FOREST RIVER INC.

2013 LP GAS RECALL
US 12V-458/CANADA 2012-305
OCTOBER 2012

RECALL SUMMARY

Example A

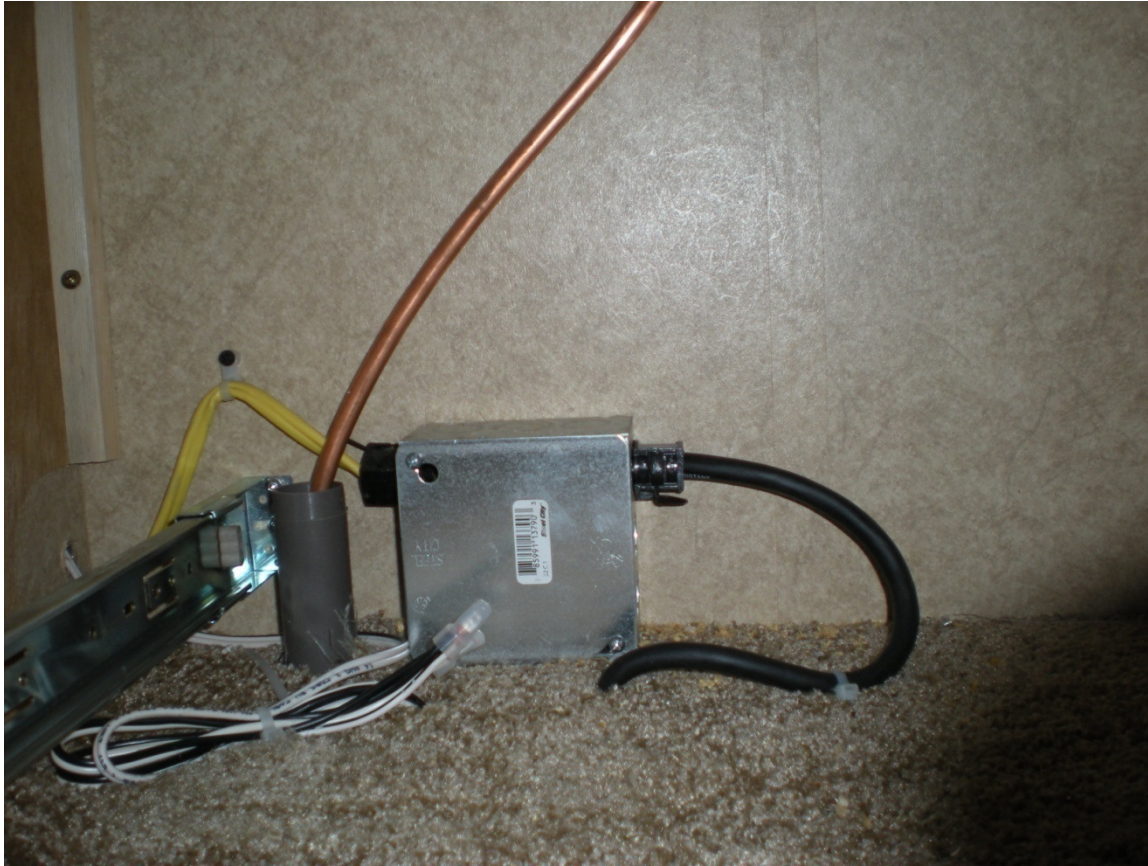
- **Start by removing the bracket and U-bolt on the LP line, the grounding bracket, ground wire, and black plastic flex guard. All found under the slide room (Example A). Disconnection of the LP line is not required or necessary.**

- **Fit the new bracket into place with the U-bolt holes against the slide room floor. Mark where the new U-bolt holes will need to be drilled.**
- **Locate the interior 12 volt junction box under the range or refrigerator appliance (Example B). Remove the drawer under the appliance to access the junction box for inspection. The junction box and/or wiring may need to be moved before drilling into the slide out floor. You can simply raise the junction box to prevent any disconnections (Example C)**

- **Drill the marked holes in the floor from under the slide out.**
- **Install ground wire to the steel LP line using the new smaller ground strap.**
- **Insert the U-bolt and attach the LP line to the bracket. The U-bolt must secure the LP line at the collar, not at the fitting (Example D).**
